COMMUNITY DEVELOPMENT DEPARTMENT
80 Columbia Avenue ♦ Marysville, WA 98270
(360) 363-8100 ♦ (360) 651-5099 FAX

Re: Maryville Corporate Center – *Technical Review 2*
PA 22004

RE: Marysville Corporate Center, File# PA22-004
Binding Site Plan
15908 47th Ave., Multiple Parcels

SUBJECT: PA 22-004 – Marysville Corporate Center

SHEET 3 OF 4

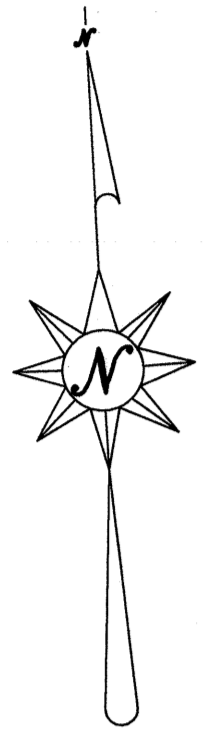
- j. Remove "A.F. NO. _____" from all sheets.
- k. Remove DECLARATION, ACKNOWLEDGEMENTS, CITY ENGINEER APPROVAL, COMMUNITY DEVELOPMENT APPROVAL, MAYOR APPROVAL, RECORDING CERTIFICATE, TREASURER'S CERTIFICATE AND LAND SURVEYOR'S CERTIFICATE and language from Sheet 1 of 8. This information is only required on the FINAL BSP to be recorded.

Additionally, remove "SHEET 5 OF 8" and "SHEET 6 OF 8" from Sheet 1. These are not correct references and are not needed.

SHEET 4 OF 4

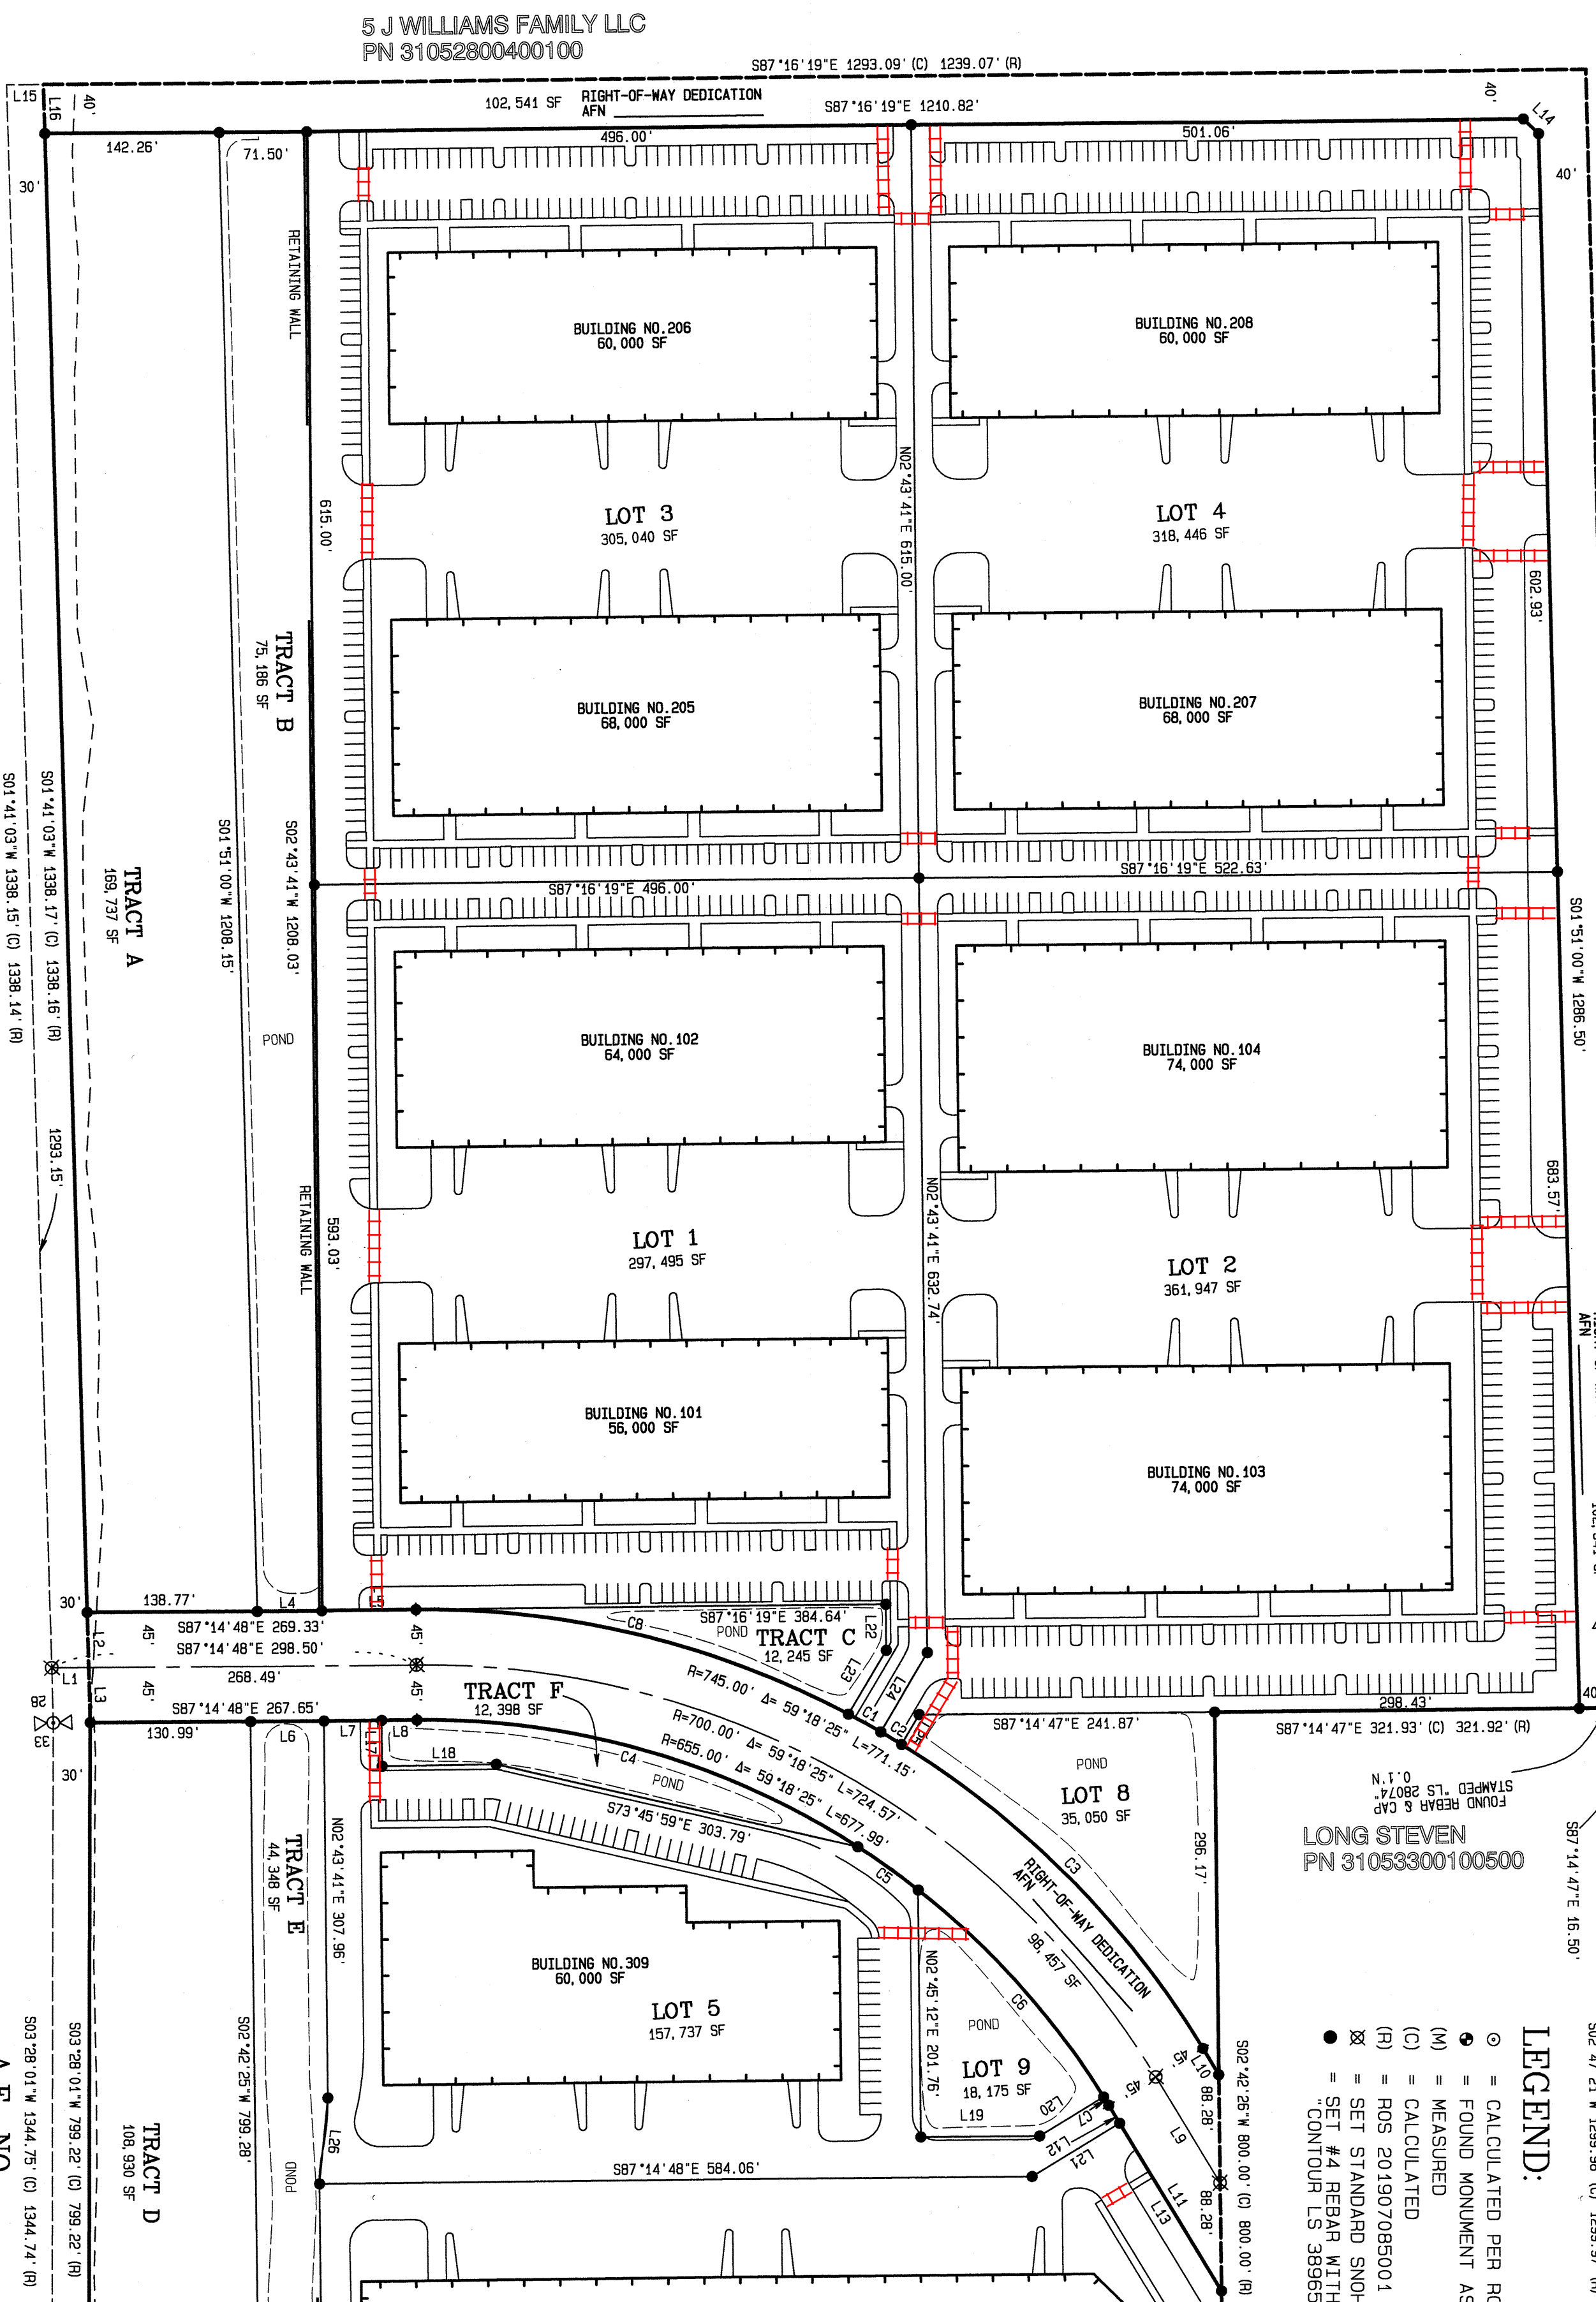
TR2 Comment: Phase lines have not been identified on any of the sheets. Sheet 4 of 8 includes zoning compliance information.

- l. Provide a Table that identifies each TRACT the SF and proposed Use of the TRACTS.
- m. Sheet 4 of 8 includes a "ZONING COMPLIANCE - TOTAL PHASE" section. Confused what this information is representing? Compliance with the LI bulk & dimensional standards as outlined in [MMC 22C.020.080\(2\)](#) is required. What is "Landscape Area," "Sidewalk/Drive Aisle Area" and "Building Area," and what Phase is it for? The setbacks noted are incorrect, the base height allowance is not noted and the math for the maximum impervious surface is not provided. Please amend and provide the additional information noted.
